Public Hearing #10

Consideration of Petition No. RP-052-14, Max Fuller, Owner, and Moore Bass Consulting, Inc., Agent, request to add six (6) lots to the Minor Subdivision Plat for Max Fuller, with said property being located in Land Lot 87 of the 5th District and fronting on South Jeff Davis Road.

PETITION NO: 1235-14 & RP-052-14

RE: Rezoning Petition 1235-14 and Revised Plat RP-052-14
South Jeff Davis Road Subdivision
MB Project No.: A41.008

SHEET TITLE
CONCEPTUAL PLAN
SHEET
1.0

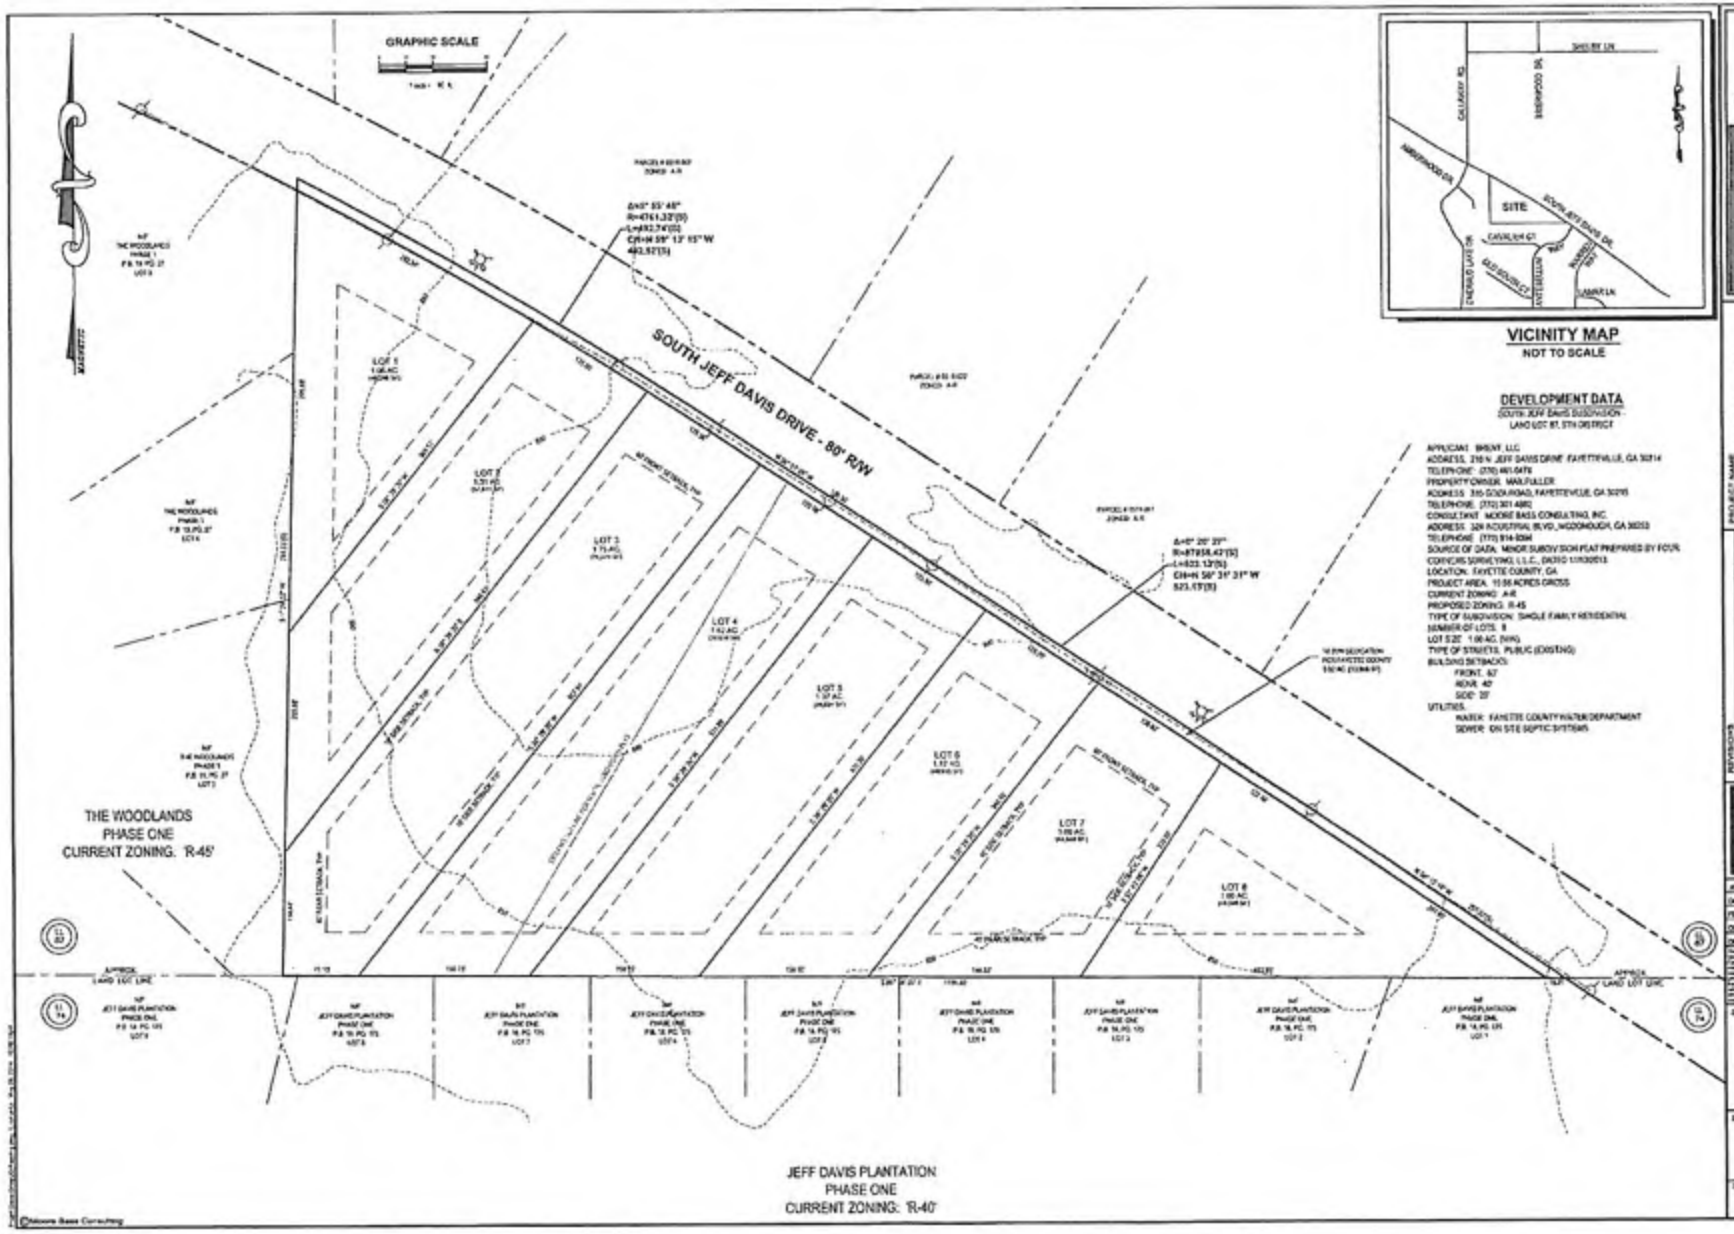
The Concept Plan submitted indicates eight (8) possible access points from South Jeff Davis Drive. South Jeff Davis Drive is classified as a Minor Arterial road on the Fayette County Thoroughfare Map. The applicant shall be aware that Public Works/Engineering has concerns with adequate site distance and may require shared driveways (see below).

- Lots 1 and 2 have basically unlimited sight distance to the west or left and approximately 525-600 feet of sight distance to the right. I determined this by standing next to the fire hydrant in front of proposed Lot 1, which put my eye level at about 3.5 feet above where a driveway would be, and measuring the distance to the mailbox I could see across the street from Lot 4. I repeated this exercise in front of Lot 2.

- The lots that would be considered along the top of the hill, Lots 3, 4, and 5, have well over a thousand feet of sight distance in both directions.
- Lots 6 and 7 appear to present the biggest sight distance challenge. In my opinion, because the vertical curve in the road is so long and gradual, the required sight distance is achievable from every possible driveway location. However, if these two lots are close enough to cause concern an option could be to have them share driveways with the lots on either side of them. In other words, Lots 5 and 6 could share a driveway along their common boundary line and Lots 7 and 8 could share a driveway along their common boundary line.
- Lot 8 is more than 500 feet from the top of the hill and therefore over 500 feet of sight distance exists to the left. Sight distance to the right is well over a thousand feet.

1. The proposed rezoning increases number of possible curb cuts onto South Jeff Davis Road from 2 to 8 and adequate sight distance may not be available at all locations. Staff recommends that applicant determine sight distance at each proposed lot on the Revision to the Minor Subdivision Plat. Shared driveways (maximum of two homes per driveway) may be required. We do not want to create, via rezoning, a lot with safety issues to future homeowners or traveling public.

2. The increase in density will allow four times the impervious area without requirement for storm water management since no new road construction. This may impact downstream lots in Jeff Davis Plantation. Environmental Management has more input on this issue.

- Bottom line seems to be that sight distance has been checked by the applicant and appears adequate for all lots. Plus option for shared driveways on lots 6 and 7, if needed.
- For final plat we'll have to double check these and possible require access easement on the appropriate lots.

The applicant is advised that the Concept Plan is for illustration purposes only. Any deficiencies must be addressed at the time of submittal of the Revised Minor Subdivision Plat for Max Fuller.
